BULLETIN 9

PROJECT: Yonkers Community School 35 – Justice Sotomayor

RE: Coordination Drawings – Architectural Floor Plans
Academic Building

Project Name: Yonkers Community School 35 – Justice Sotomayor
 Summary of Adjustments – MEP Coordination – Academic Building

A200

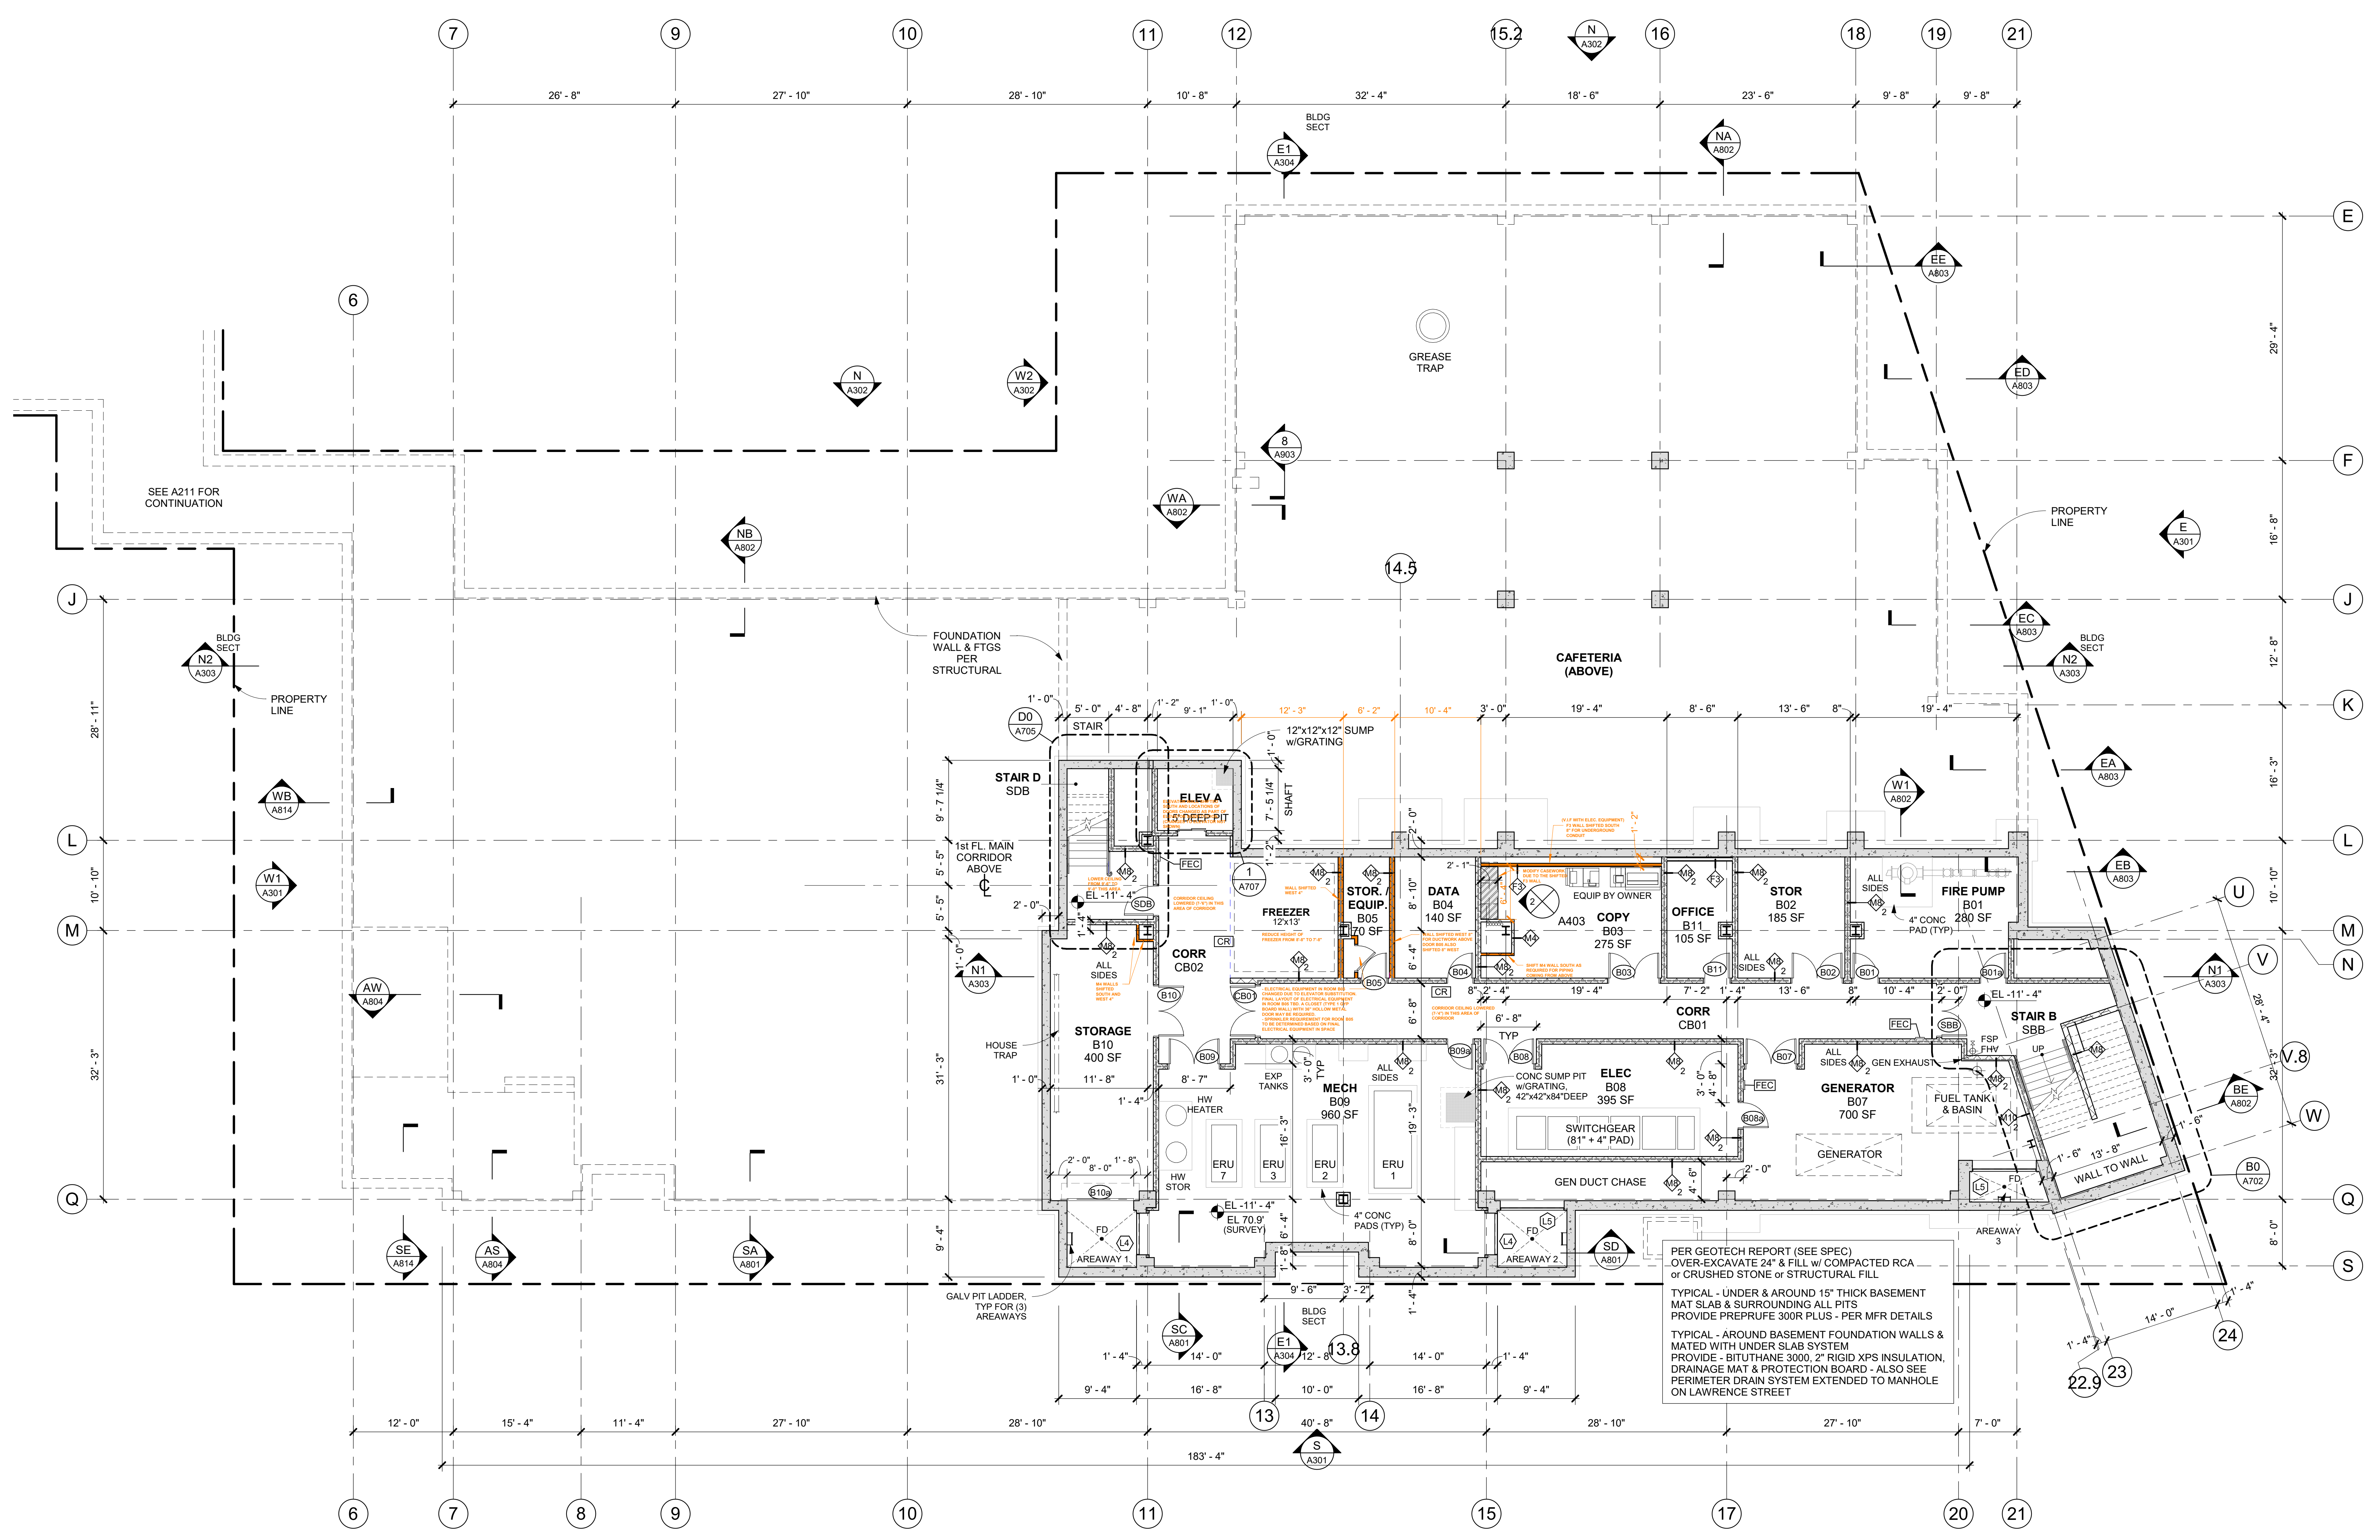
COPY B03	North Furring wall shifted South to accommodate underground conduit and electrical boxes. Reduce length of casework along West wall. Chase wall in SW corner shifted South for clearance of piping above, final location to be determined in field.	See REVISED SHEET A200
EMR B05 (STOR. / EQUIP B05)	West M8 wall shifted West 4". East M8 wall shifted West 8". EMR name changed since it is no longer a formal elevator machine room due to the elevator substitution. Final layout of electrical equipment in this space still to be determined. Work may require a closet to enclose certain electrical panels, and final layout of electrical equipment will determine whether sprinkler is required in this space.	See REVISED SHEET A200
STORAGE B10	Chase wall in NE corner shifted 4" each direction for clearance of piping above.	See REVISED SHEET A200
FREEZER	Reduced height of freezer for clearances of equipment above.	See REVISED SHEET A200

STAIR D	Lowered ceiling in lower landing area to 9'-0"	
CORR CB01	Ceiling to be lowered in portion of corridor to 7'-4". Balance of corridor TBD.	
CORR CB02	Ceiling to be lowered to 7'-6"

A201

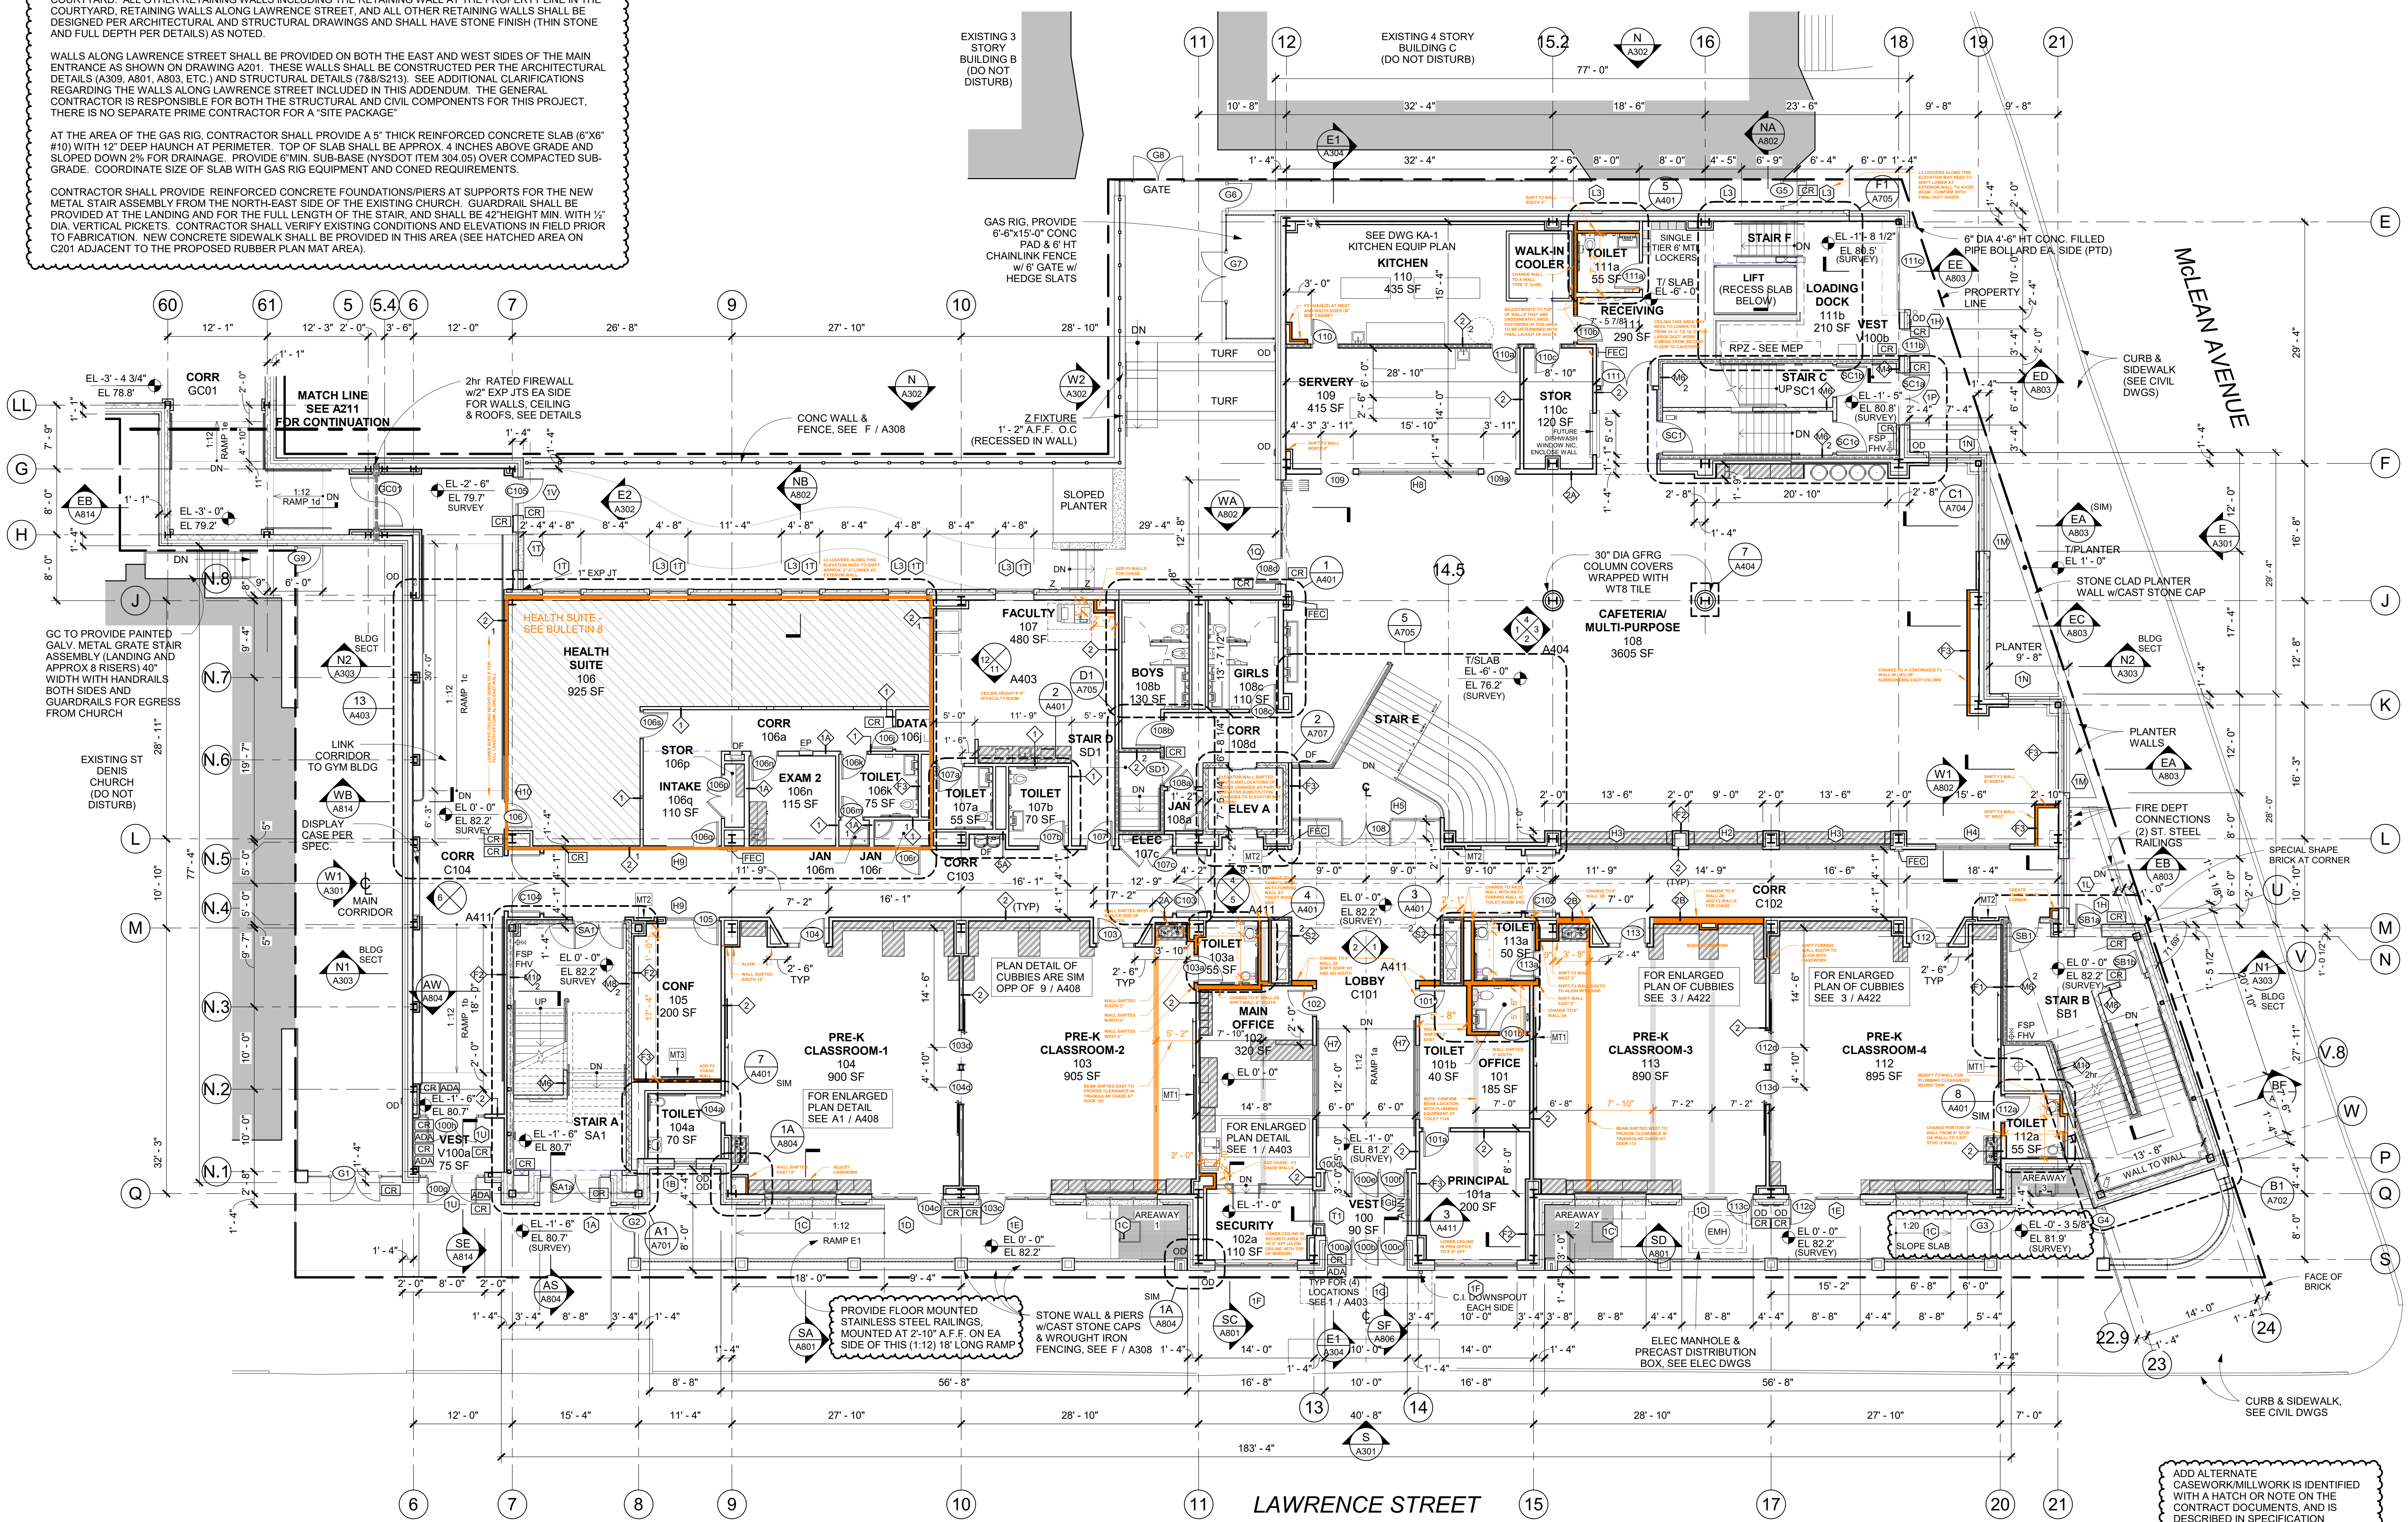
LOBBY C101	Two walls changed from 3-5/8" stud to 6" stud. Doors 101 and 102 shifted south accordingly.	See REVISED SHEET A201
CORR C102	Add F2 chase wall in SE corner	See REVISED SHEET A201
TOIL 101b	West wall shift 2" East, South wall shift 3" South.	See REVISED SHEET A201
MAIN OFFICE 102	Add F3 chase in SW Corner	See REVISED SHEET A201
PRE-K CLASS 103	Shift wall adj. to sink 6" West. Reduce size of sink counter accordingly. Shift chase wall south 2".	See REVISED SHEET A201
TOIL 103a	Swap location of toilet and sink. Modify East wall to create a chase so that plumbing is not located in a shaft wall. Shift furring around column and shift West wall 3". Change South wall from 3-5/8" stud to 6" stud.	See REVISED SHEET A201
PRE-K CLASS 104	Shift chase walls along West side of classroom in each corner. Modify / reduce length of casework along South window wall accordingly.	See REVISED SHEET A201
CONF 105	Add F3 chase wall at South end of room.	See REVISED SHEET A201

HEALTH SUITE 106	Revised layout of future Health Suite.	See Bulletin 8
FACULTY 107	Add chase in North East corner.	See REVISED SHEET A201
CAFEERIA 108	East Chase wall to be continuous in lieu of wrapping columns J-19 and K-19. Shift chase walls in SE Corner West and North.	See REVISED SHEET A201
SERVERY 109	Shift chase wall in SW corner 8" to the North	See REVISED SHEET A201

KITCHEN 110	Add chase wall(s) in SW corner for Mop Cabinet. Change East wall from type '1' to a type '2' 2-HR	See REVISED SHEET A201
TOIL 111a	Shift North wall 3" South.	See REVISED SHEET A201
TOIL 112a	Modify chase wall for plumbing behind sink. Change portion of West wall from a 6"stud to 3-5/8" stud.	See REVISED SHEET A201
PRE-K CLASS 113	Change corridor walls from 3-5/8" to 8" as noted. Modify Casework and adj. chase wall accordingly. Shift F2 chase wall south to align with sink. Shift F2 wall West 2" to enlarge counter for installation of sink.	See REVISED SHEET A201
TOIL 113a	Swap location of toilet and sink. Modify West wall to create chase so that plumbing is not located in a shaft wall. Change South wall from 3-5/8" stud to 6" stud. Shift East wall East 8" for ADA clearances.	See REVISED SHEET A201

PRINCIPAL 101a	Lower ceiling from 10'-0" to 9'-6" AFF in Principal Office	
SECURITY 102a	Lower ceiling from 10'-6" to 10'-0" AFF this area. Adjust bulkhead between Security and Main Office accordingly.	
FACULTY 107	Lower ceiling from 9'-0" to 8'-8" in Faculty Room	
RECEIVING 111	Ceiling may need to be lowered to 14'-2" AFF – Coordinate with ductwork shops.	
CORR C104	Lower soffit along East side of corridor to 8'-0" AFF

Exterior Wall Col Line J	Exterior L3 louvers will get lower 2-4" to avoid steel beam. Should have no impact on ceiling heights	
Exterior Wall Col Line E	Exterior L3 louvers may need to get lower to avoid steel beam. Confirm with final duct shops	
LOBBY C101	Clear width of chases on each side 2'-1". Confirm with final duct shops.

RECEIVING 111	Modifications to the shaft wall to get ductwork from the hood and the supply/return from cafeteria to the Second Floor. Two large ducts in this area that overlap walls above the ceiling, will need to investigate ways to support tops of walls in these areas or adjust duct work.	Further information to follow
PRE-K CLASS 103	Beam shift to provide clearance in chase adj. to Door 103. Adjustment to beam was shown on the reviewed shop drawings.	See REVISED SHEET A201
PRE-K CLASS 113	Beam shift to provide clearance in chase adj. to Door 113. Adjustment to beam was shown on the reviewed shop drawings.	See REVISED SHEET A201
